## Base document for ALKS for low speed application Proposal from the Small Drafting Group

## Proposal for Technical Requirements for an Automated Lane Keeping System

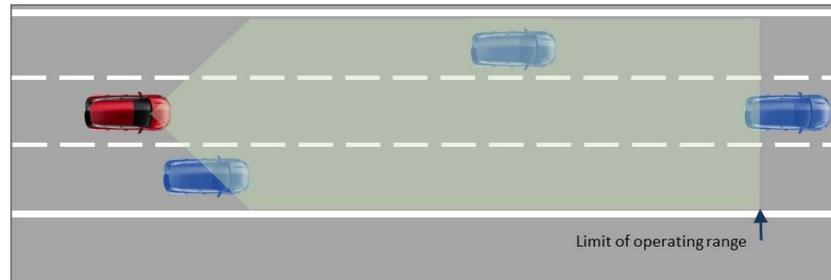
<Korean text> [KATRI19]

$$d_{\min} = \max(\min(v_{\text{ALKS}} * t_{\text{front1}}, v_{\text{ALKS}} * t_{\text{front2}}), 2)$$

- $d_{\min}$  = the minimum following distance
- $v_{\text{ALKS}}$  = the actual speed of the ALKS vehicle in [m/s];
- $t_{\text{front1}}$  = minimum time gap in seconds between the ALKS vehicle and a leading vehicle in front =  $0.2 + \frac{2.9 * v_{\text{ALKS}}}{36.1}$
- $t_{\text{front2}}$  = minimum time gap of 2 seconds between the ALKS vehicle and a leading vehicle in front

Notwithstanding the result of the formula above for actual speeds below 24m/s the minimum following distance shall never be less than 2 m.
